Ammonium Nitrate Storage and Distribution Facility

Response to Submissions Report

Crawfords Freightlines

April 2013

**Figure 1 - Crawfords AN Storage Facility
Sandgate Proposed Buffer/Community
Exclusion Zone**
Crawford Freightlines Pty Ltd -
Response to Submissions

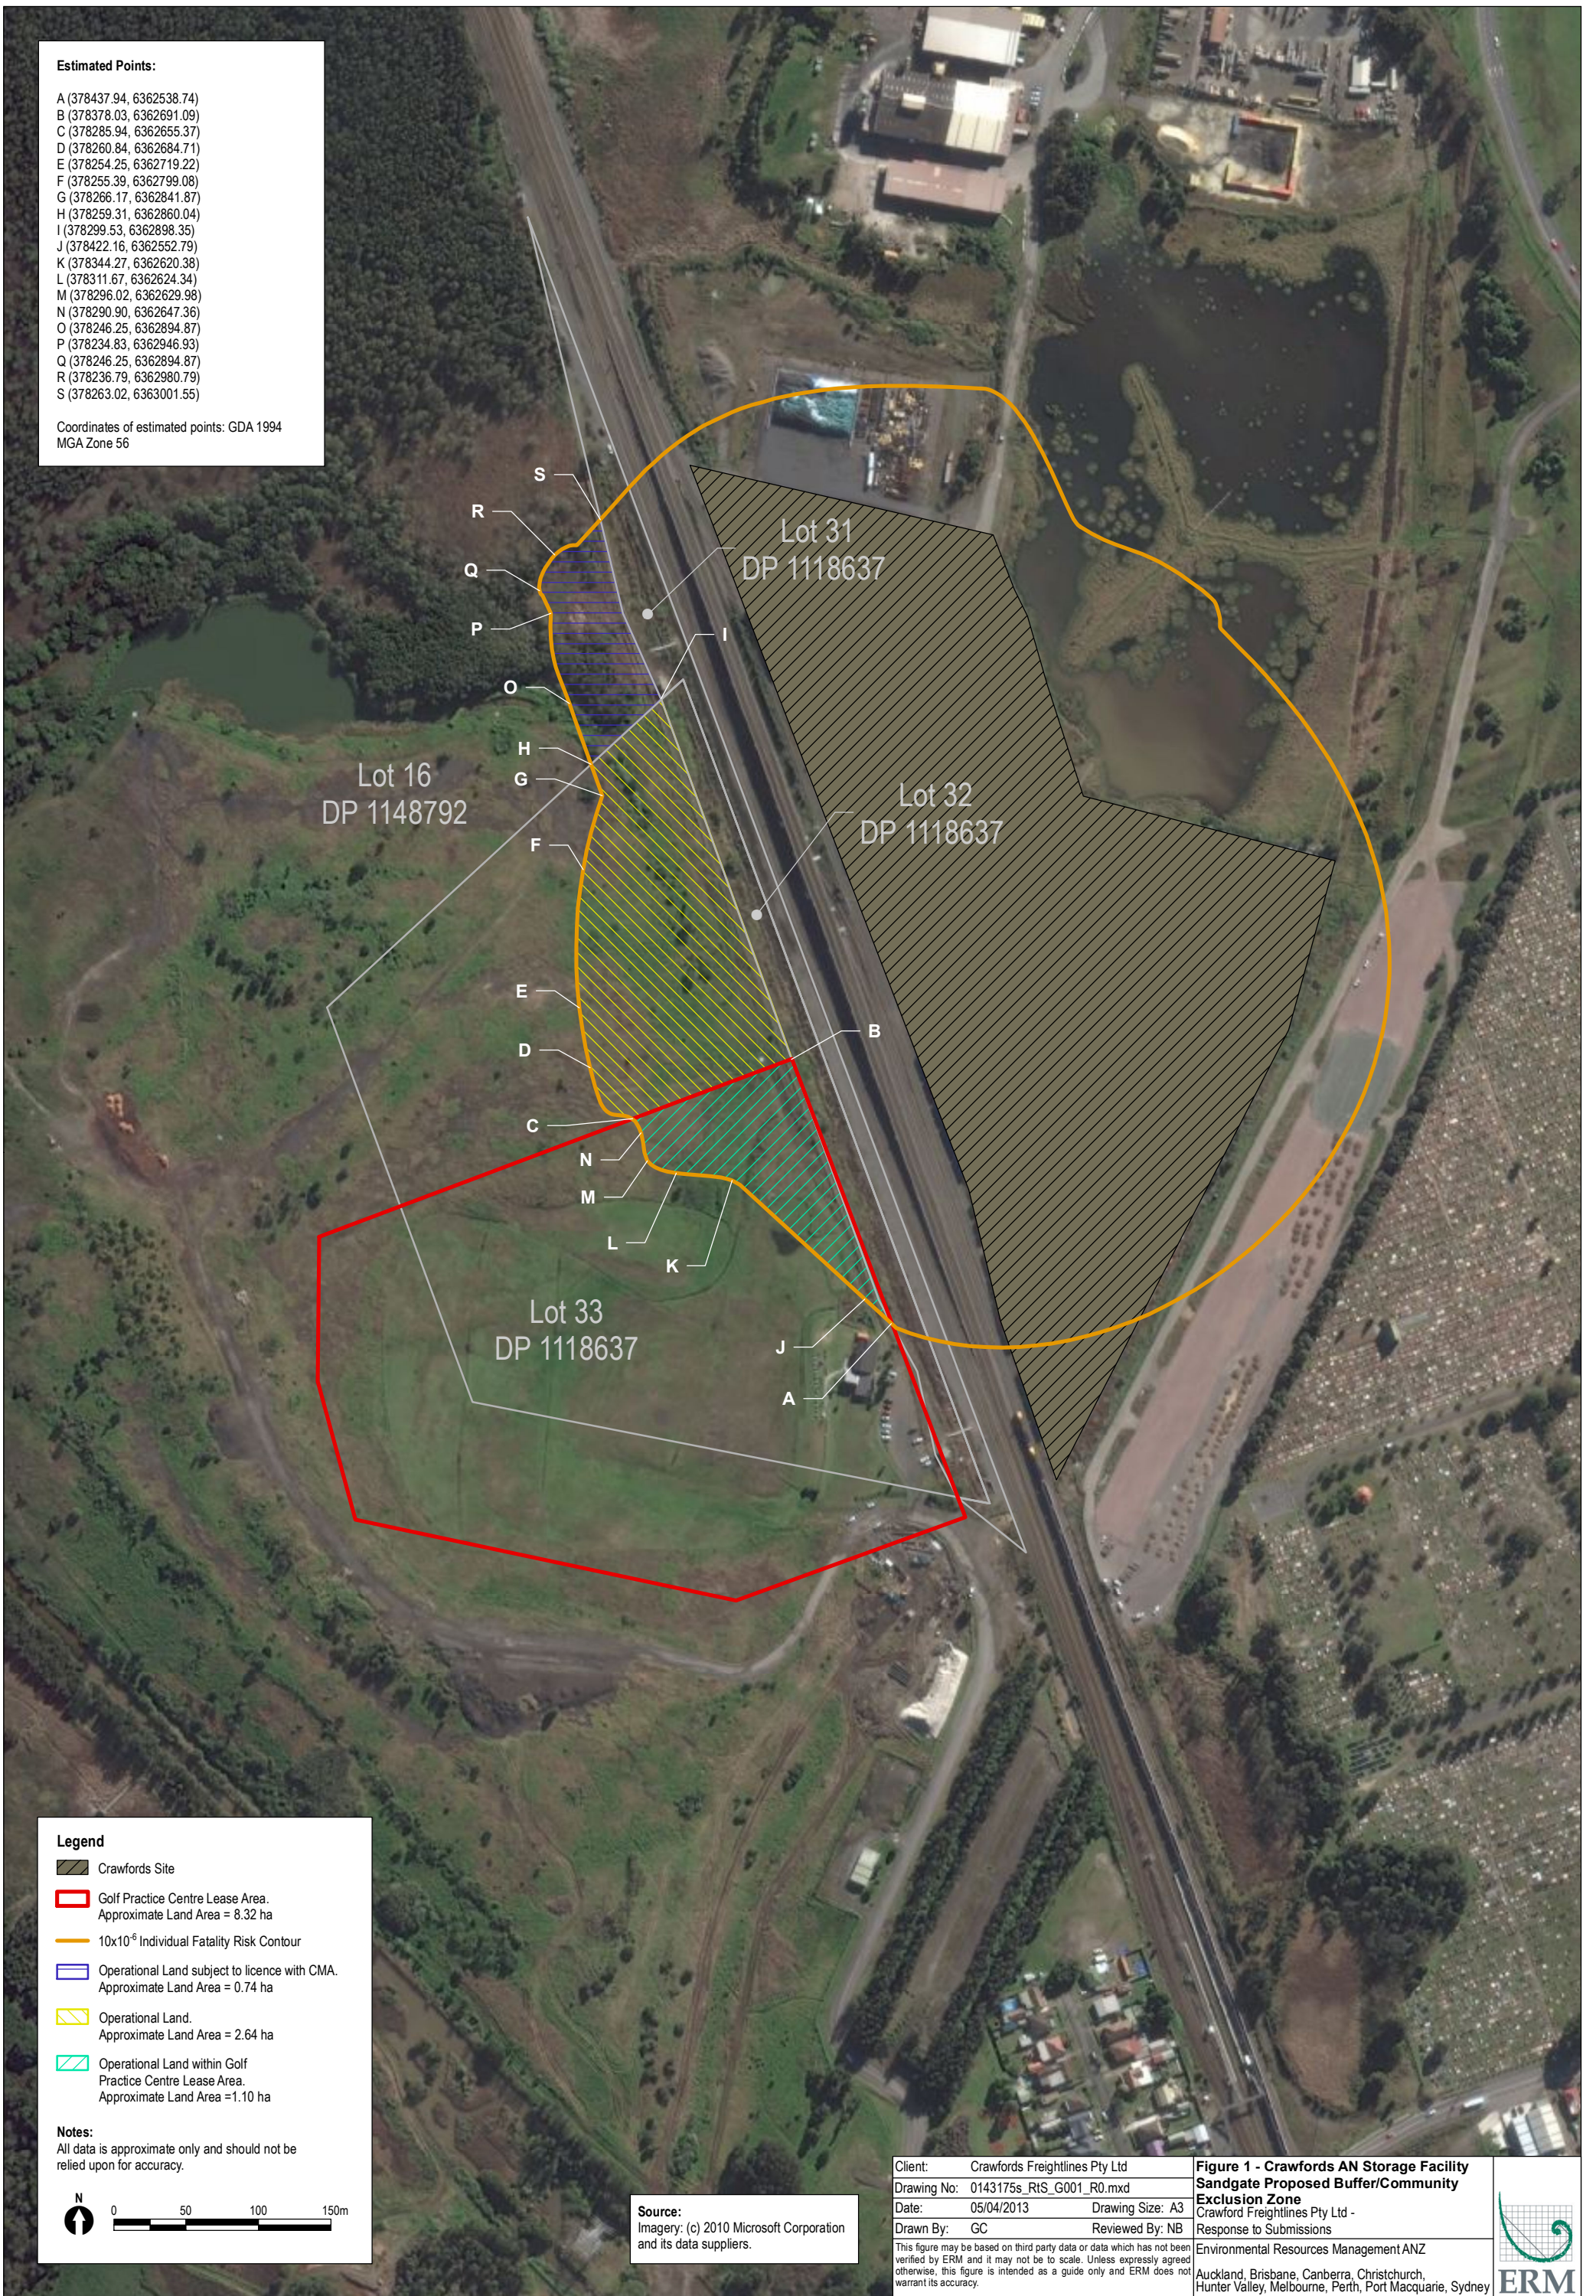
One specific matter of public safety relates to limiting public access to the area affected by the risk contours identified as the proposed buffer/community exclusion zone shown on *Figure 1* of this RTS report. The Proponent is continuing to progress actions to restrict public access to the buffer area including the area of 'open space' within the risk contour located to the west of the Main Northern Railway corridor (see *Annex A*). The land comprises two parcels of land, which are both owned by Newcastle City Council (NCC). Part of one of these parcels is located within the Golf Driving Range lease area and the balance of the buffer area is outside this lease area.

Crawfords have been involved in negotiations with the leaseholder of the practice golf range at Sandgate, and these negotiations are at an advanced stage and are likely to result in a satisfactory outcome, being Crawford's exclusive right to control land use within the buffer area. Crawford have advised that they have reached agreement with the leaseholder in respect to securing the right to control land use in this part of the lease area. This agreement is in the process of being documented and will be forwarded to DP&I when it is in a form acceptable to both parties.

Negotiations with NCC have also been progressing well in respect to the balance of the land within the buffer area (over land owned by Council). ERM understands that Council's solicitor has been instructed to prepare the necessary documentation for review by Crawford's solicitor from Rankin and Nathan. Once again, when in a form acceptable to both parties, it will be forwarded to DP&I.

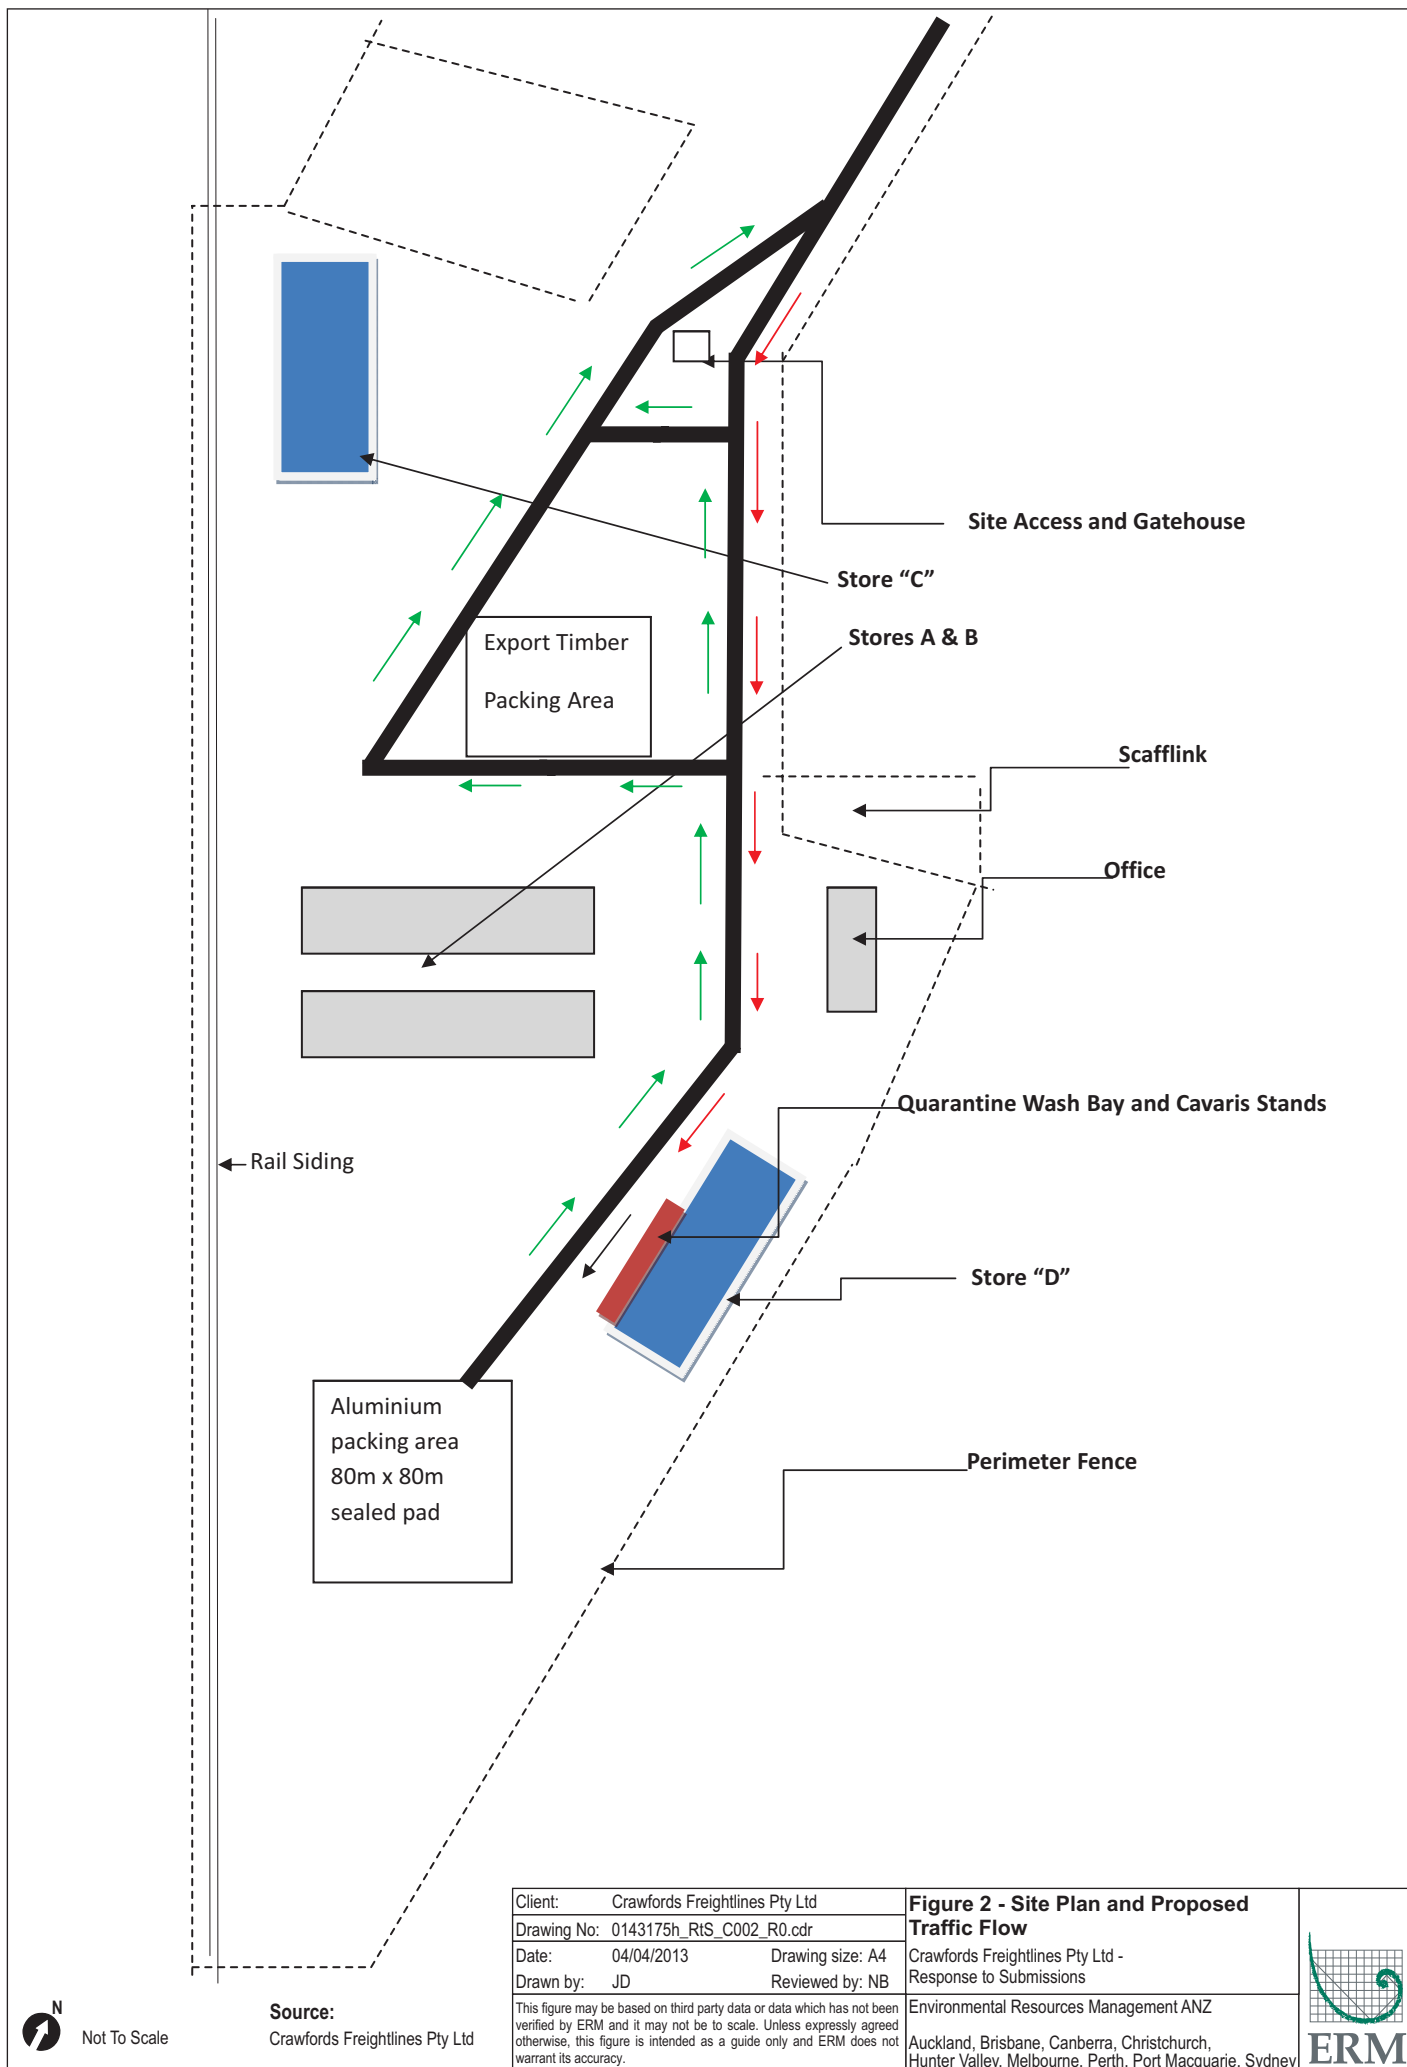
DP&I	1.02		The EIS/PHA indicated that the route/s followed by the laden and unladen trucks to and from the facility would be via a single entry point, north of the facility. Please provide more detailed	Recent modifications to the entry and access road configuration within the site have incorporated the separation of inbound and outbound traffic flows at the site entry/gatehouse (refer to <i>Figure 2</i> in

Authority/ Author	ERM Ref	Issue Raised	Submission	Response
			information in the RTS on the route/s taken by the laden and unladen trucks including a clearly marked up map. The Department also wishes to clarify in the RTS what steps have been taken to reduce the likelihood of an accident at the gate of the facility? In addition, what are the risk implications to the surroundings (eg a truck accident at the gate may cause an impact to St Joseph's)?	the RTS report). The sign posted speed limit along the access road to the site is 20km/hr, therefore reducing the potential for any traffic incidents along the access road or at the gatehouse entry to the site. The Traffic Impact Assessment considered the intersection of the site access road and Old Maitland Road. Based on the indicative speed limit of 50km/hour the required visibility for the intersection is 69m. The existing intersection visibility exceeds 100m in both directions. Section 3.2.1 of the Traffic Impact Assessment states that there is currently sufficient capacity to accommodate the light and heavy vehicle trips generated by the proposal and other nearby industrial developments and that no queues form on the service road during peak activity. In summary, reduced speed limit on the service road, the adequate sight distances at the intersection with Old Maitland Road, the definition of traffic flows within the site (as shown on <i>Figure 2</i> of the RTS report) will facilitate forward movement of heavy vehicles and traffic flow on site, and serve to further minimise the risk of a queue forming on the site access road and reduce the risk of a road accident.

In response to a request from the DP&I, Crawford's have identified traffic flow routes within the site for laden and unladen heavy vehicles (see *Figure 2* of this RTS report) providing for forward movement of vehicles to minimise delays on site and also separation of laden and unladen heavy vehicles for some of the internal roads. These site specific measures in combination with the reduced (20 km/hour) speed limit on the service road and the adequate sight distances both ways (100 m) at the intersection with Old Maitland Road, will serve to minimise the risk of a queue forming on the access road to the site and reduce the risk of accidents.
